ST. TAMMANY PARISH

Addendum No.: 2

Bid#: 25-13-2

Project Name: Coroner Chiller Addition

ME101

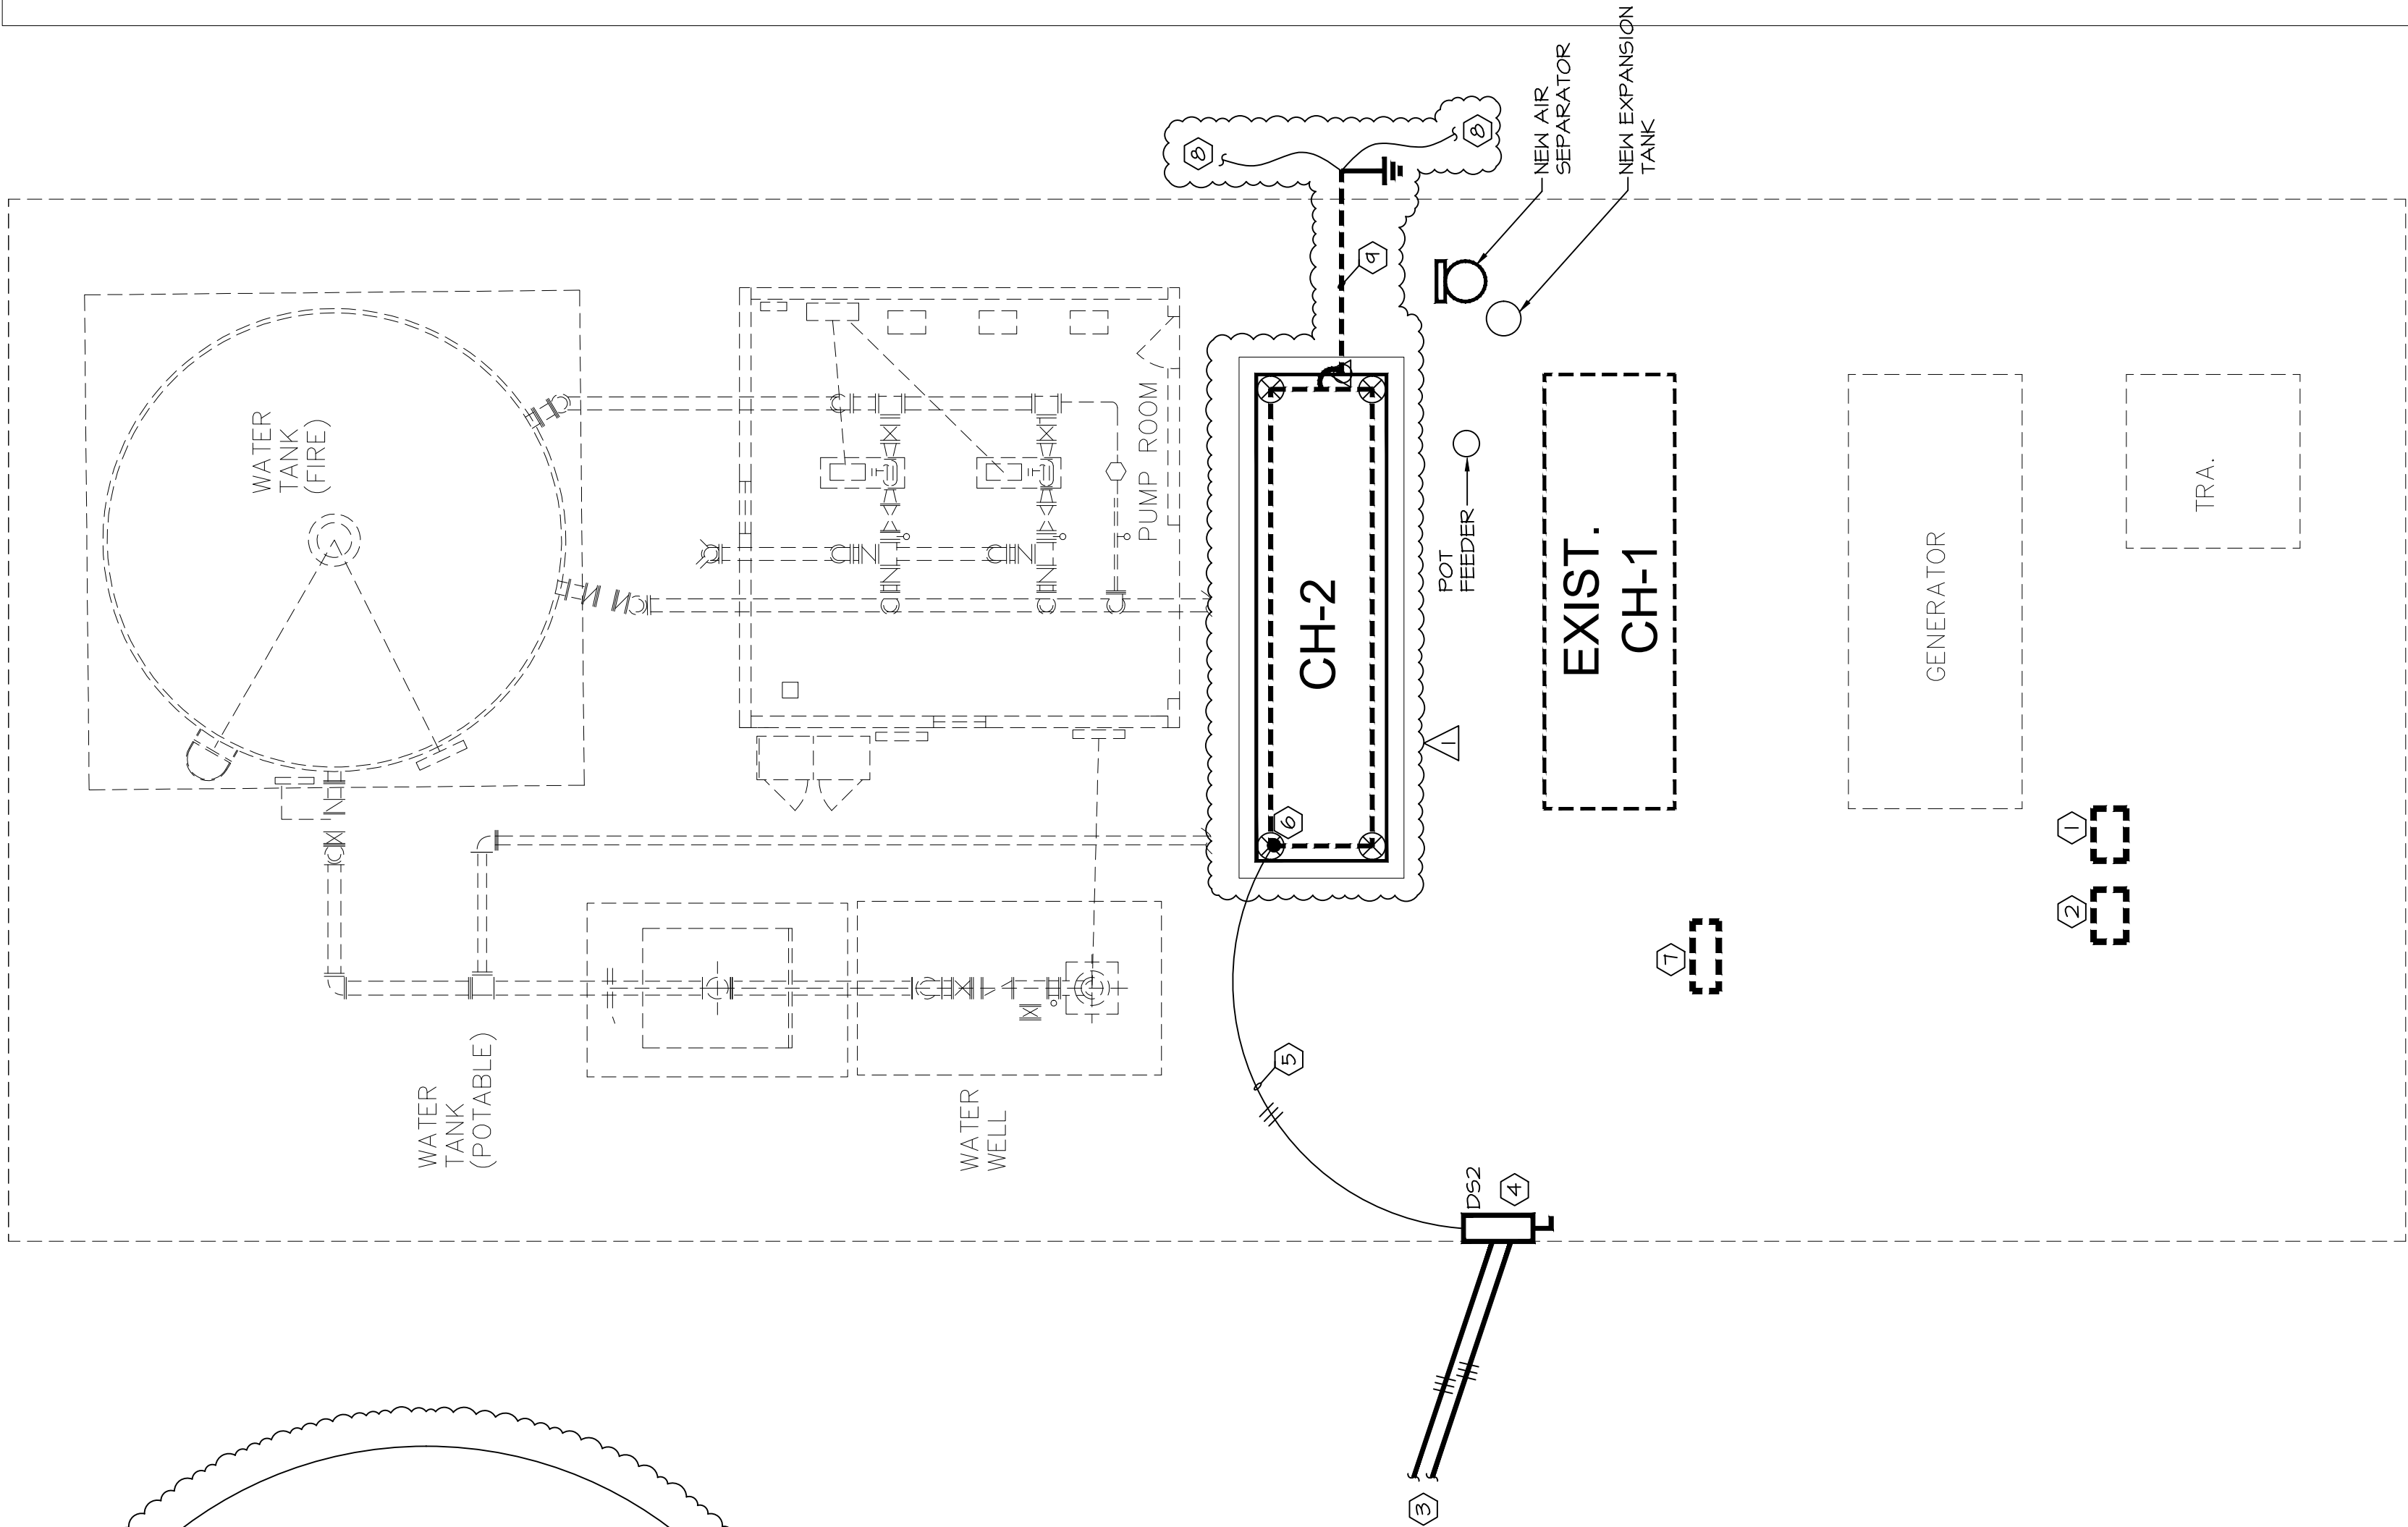
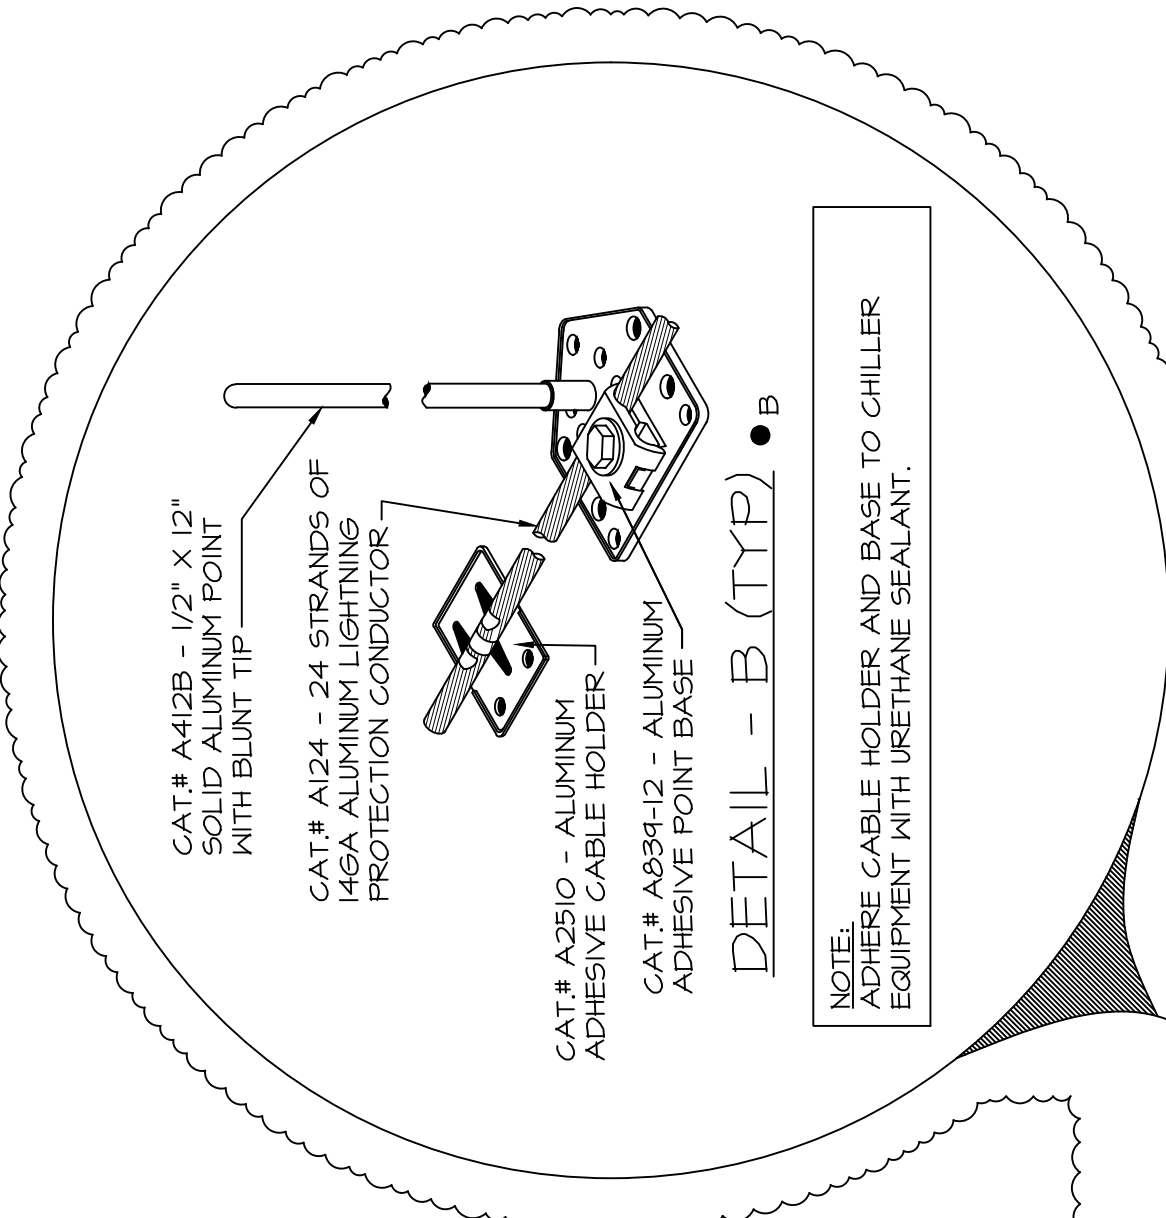
- Item No. 1: See attached attendance sign-in sheet for the mandatory pre-bid held April 29, 2025, on-site.
- Item No. 2: See attached, added specification section: 26 41 00 Lighting Protection specifications.
- Item No. 3: See attached revised specification section 23 05 00 HVAC Systems and piping. Revision to chiller specification.
- Item No. 4: Drawing revision to sheet ME101: Addendum #2 Dated 5/9/2025. Revision to the controls conduit routing at the building.
- Item No. 5: Drawing revision to sheet M101: Addendum #2 Dated 5/9/2025. Revision to existing piping.
- Item No. 6: Drawing revision to sheet M201: Addendum #2 Dated 5/2/2025. Revision to Chiller Schedule.
- Item No. 7: Drawing revision to sheet E101: Addendum #2 Dated 5/9/2025. Added lighting protection.
